SUBJECT: WATTS BAR NUCLEAR PLANT - NSRS REPORT R-80-21-WBN

NSRS Report No. R-80-21-WBN

Subject: Review of the WBN CONST Project Program Governing the  
Installation and Inspection of Safety-Related Piping and  
Supports

FIGURE 2.0  
 CAUSE/EFFECT CHART FOR  
 PIPE HANGER INSTALLATION  
 PROBLEMS

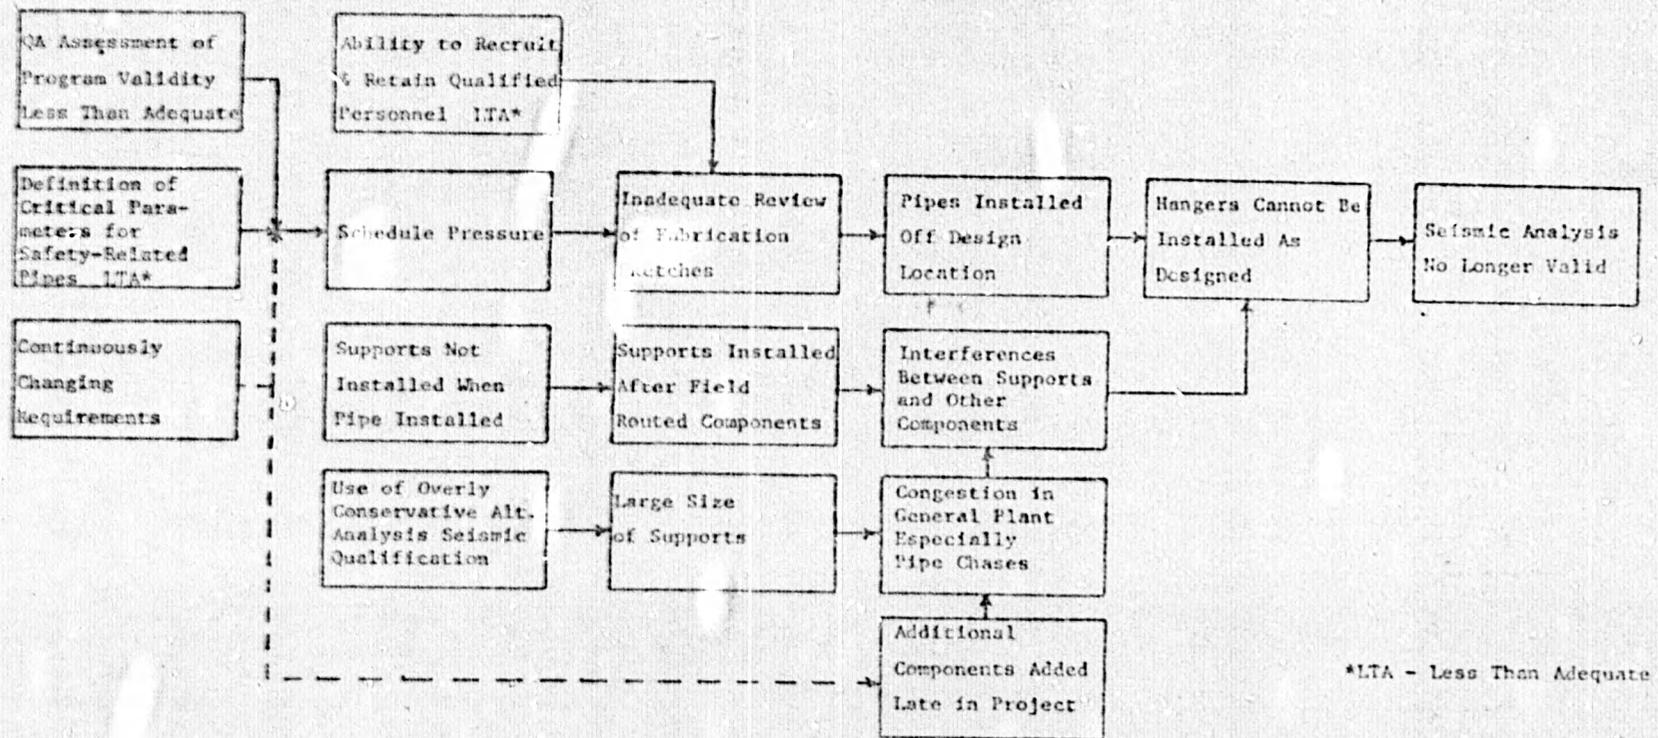
- A problem was encountered in obtaining the permanent hangers and supports in a time frame consistent with the installation of the safety-related piping. Consequently, the permanent piping was installed on temporary hangers. These factors in and of themselves did not create a problem. However, installation of field routed (located) structures, systems, and components too close to the piping to allow installation of the permanent piping and supports transpired. This has and is causing difficulties with the installation of permanent supports.

- Use of different reference points to locate piping and to locate hangers resulted in further complications. Pipe location is referenced off of column centerlines while supports and hangers are referenced off of nominal wall, ceiling or floor faces. The result in some instances is a support or hanger that totally misses the piping that it is supposed to support, even though both pipe and support are installed per their respective design requirements. This problem with the reference points needs to be resolved. (See recommendation B, Section III.)

EN DES organizations that specify locations for piping and supports at WBN should review their current practices to determine the extent of this problem. Based on the findings of the review, these organizations should specify corrective actions to eliminate this problem on present and future drawings under their control and on drawings issued to the WBN CP or already implemented by the WBN CP.

FIGURE 1.0  
 CAUSE/EFFECT CHART FOR  
 RESIDUAL PIPE STRESS

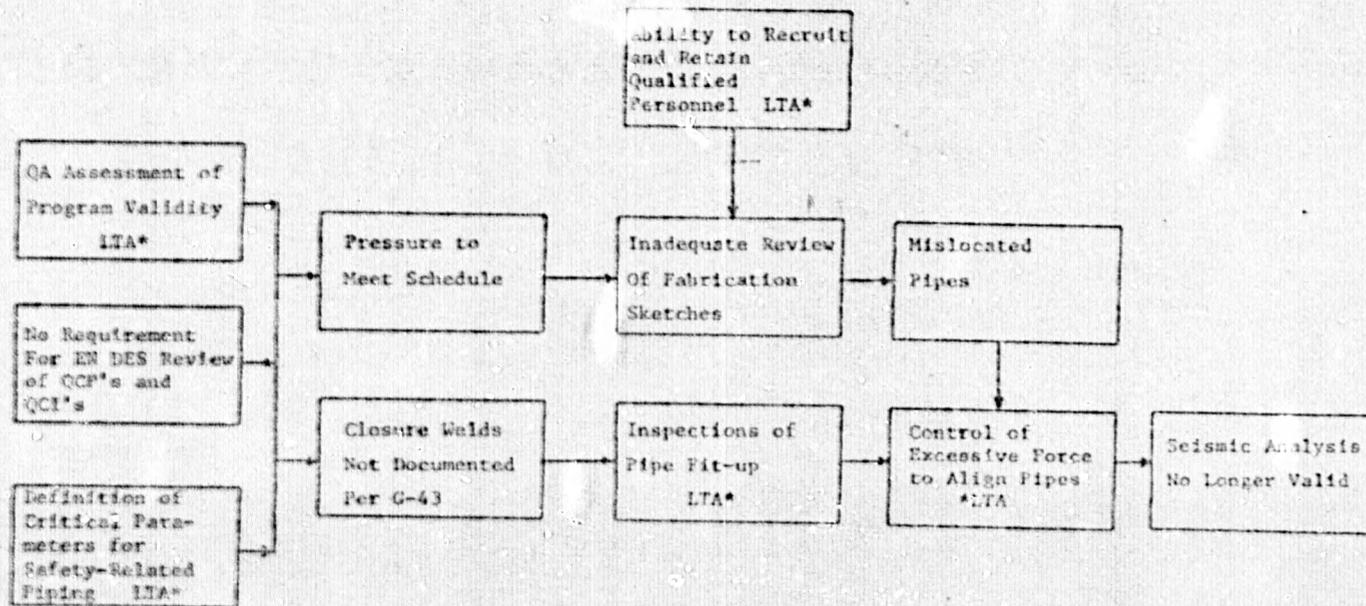
Failure to formally document closure sections in piping and to control preload in piping and nozzles as required in General Construction G-43 is an example of a significant design requirement that was not formally implemented in the quality control program for the installation and inspection of safety-related piping and supports. As a result, varying amounts of preload are suspected to exist in the piping and nozzles; because the 1/16-inch maximum misalignment of closure weld joints was not adhered to. External force of varying degrees was utilized to accomplish piping to piping and piping to nozzle alignments. Existence of this preload has the potential to invalidate the seismic analysis.

- c. G-43 does contain some specific requirements such as the 1/16-inch maximum allowable misalignment of pipe joints while swinging free on supports for closure connection final assembly. This specific requirement is in G-43 to prevent significant preload on the final assembly connection which is a general assumption used in the seismic analysis. The concern for minimizing preload is justified per the seismic analysis; however, this requirement does not reflect conditions achievable from a constructability standpoint or criteria which are consistent with the ASME code on weld joint misalignment and on "cold-springing." Since the ASME code is utilized more extensively than G-43 and since the weld joint fit-up inspections are performed by welding unit personnel, the requirements of G-43 in this area tend to not be vigorously followed. Consequently, a documented program to minimize pre-load due to use of external force to effect closure connection alignment was never implemented at WBN. Piping fit-up was generally checked against the requirements of the ASME code. As a result, instances of preload outside the limits allowed by G-43 and subsequently the seismic analysis may exist in nozzles and piping at WBN. The impact of this situation on the seismic analysis cannot be determined until after the extent and magnitudes of the preload are determined. The most important point is that a situation exists in the field which may indeed invalidate the seismic analysis. Consequently, this situation must be evaluated and resolved. (See recommendation A, Section III.)

CEB with the assistance of the WBN CP should assess the magnitude and frequency of the existence of preload in the piping. Based on these findings CEB should specify corrective actions, if any, to eliminate the problem and to ensure the validity of the seismic analysis. In addition changes to the existing program that are acceptable to both organizations should be identified and implemented to prevent recurrence of the problem in piping being installed now and in the future.
